Application No.	Applicant(s)			
	10/519,864	JACKSON, GRAEME ANDREW			
Office Action Summary	Examiner	Art Unit			
	ALAN B. WAITS	3656			
The MAILING DATE of this communication appears on the cover sheet with the correspondence address Period for Reply					
A SHORTENED STATUTORY PERIOD FOR REPLY IS SET TO EXPIRE 3 MONTH(S) OR THIRTY (30) DAYS, WHICHEVER IS LONGER, FROM THE MAILING DATE OF THIS COMMUNICATION. - Extensions of time may be available under the provisions of 37 CFR 1.136(a). In no event, however, may a reply be timely filed after SIX (6) MONTHS from the mailing date of this communication. - If NO period for reply is specified above, the maximum statutory period will apply and will expire SIX (6) MONTHS from the mailing date of this communication. - Failure to reply within the set or extended period for reply will, by statute, cause the application to become ABANDONED (35 U.S.C. § 133). Any reply received by the Office later than three months after the mailing date of this communication, even if timely filed, may reduce any earned patent term adjustment. See 37 CFR 1.704(b).

DETAILED ACTION

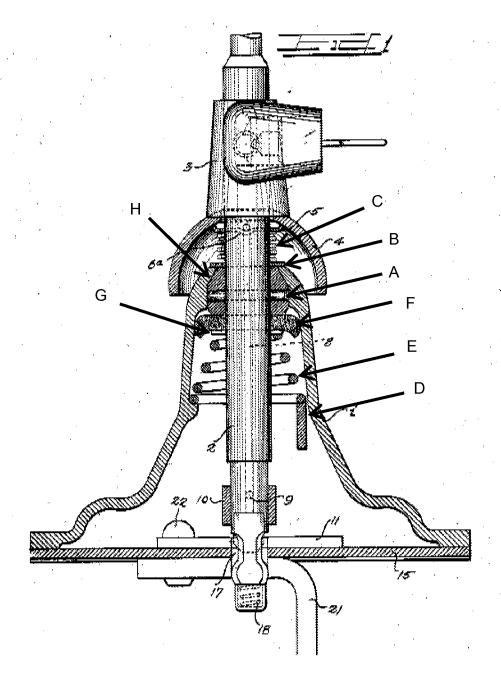
Blood discloses a similar device comprising:

- a housing (i and 4, below)
- a lever (2, below) having a longitudinal axis
- said lever being at least partially disposed within said housing (as shown below)
- a pivoting member (A, see below) in operational communication with said lever [being adapted to facilitate pivoting of said lever into a plurality of positions] (the member A allows pivoting inside the cup of the housing, fig below)
- a biasing member (H, B, C, and 5; below and fig 2) disposed proximate said lever
- said biasing member includes a first element (H, fig 2) and a second element (B, fig below) selectively engaging said first element

said first element disposed between said pivoting member and said second element (as shown below)

- said second element displaceable in a direction substantially parallel to said longitudinal axis of said lever (B slides up and down along 2, fig below)
- a third element (5, below) axially fixed to said lever relative to said longitudinal axis
- a biasing element (C, below) disposed intermediate said second element
 and said third element
- said second element disposed between said first element and said biasing element (fig below)
- [said biasing member applying a biasing force to said lever moving said lever into at least one biased position] (as element C biases the lever into a biased position, fig below)

Said biasing member is operable to bias said lever into at least one baised neutral position (the biasing member is biasing the lever in the neutral position as the spring is always there, fig above)

Said lever extends through said first element, said second element, said third element, and said biasing element to form a generally coaxial arrangement therewith (fig above)

Said first element is adapted to engage with a stop means (shape of cup inside i, fig 2)

Said stop means is operable to prevent pivotal displacement of said first element in at least one direction (prevents H from pivoting relative to i, fig above)

a second biasing member (F, G, E, and 10; fig above)

- said second biasing member includes a fourth element (G, fig above) and
 a fifth element (F, fig above) selectively engaging said fourth element
- said fifth element disposed between said pivoting member and said fourth element
- said fifth element displaceable in a direction substantially parallel to said longitudinal axis of said lever (moves along the axis that runs the length of 2, fig above)
- a sixth element (10, fig above) axially fixed to said lever relative to said longitudinal axis
- said second biasing element (E, fig above) disposed intermediate said fifth element and said sixth element
- [said second biasing member applying a biasing force to said lever moving said lever into at least one biased position] (spring E biases into a center/neutral position, fig above)

- Said pivoting member further comprises a spherical element (H, fig above)
 disposed in a retaining cup
- Said spherical element slidably engaging said retaining cup (fig above)

- A housing (i and 4, fig above) having a housing longitudinal axis (along length of 2, fig above)
- A retaining cup (where H fits into i, fig above) disposed within said housing
- A lever having a first end (top of 2, above), a second end (bottom of 2, above), and a lever longitudinal axis (along length of 2, above)
- Said lever being at least partially disposed in said housing (as shown above)
- A pivoting member (A, see above) slidably disposed in said retaining cup and being in operational communication with said lever
- [said pivoting member being adapted to facilitate pivoting of said lever into a plurality of positions]
- a biasing member (B, 5, H, C; above) disposed proximate said lever

- said first element disposed between said pivoting and said second element (above)
- said second element displaceable in a direction substantially parallel to said longitudinal axis of said lever (B slides up and down relative to 2, fig above)
- a third element (5, above) fixed relative to said lever
- a biasing element (C, above) disposed intermediate said second element
 and said third element
- said second element disposed between said first element and said biasing element (above)
- [said biasing member applying a biasing force to said lever moving said lever into at least one predetermined position] (as element C biases the lever into a biased position, fig below)

Said biasing element exerts a biasing force against said first and third elements urging the two elements away from one another (C urges H and 5 away from each other, above)

Said second element slidably engages said lever and said biasing
member applies a biasing force to said second element urging said
second element into contact with said first element (C urges B into contact
with H, above)

Applicant's arguments are once again moot, as the majority of the elements in this argument have changed. The examiner would like to further point out, however, that as the lever 2 is shifted about the pin A, that one side of the spring C is compressed more than the opposing side (due to B not pivoting with the lever as applicant has agreed in his arguments). This difference in spring compression would bias the lever into a center/neutral position.

Applicant argues that H is not slidably disposed within the retaining cup. The examiner disagrees. H either slides up and down relative to the housing to allow shifting or it slides inside of the retaining cup of the housing to allow shifting.
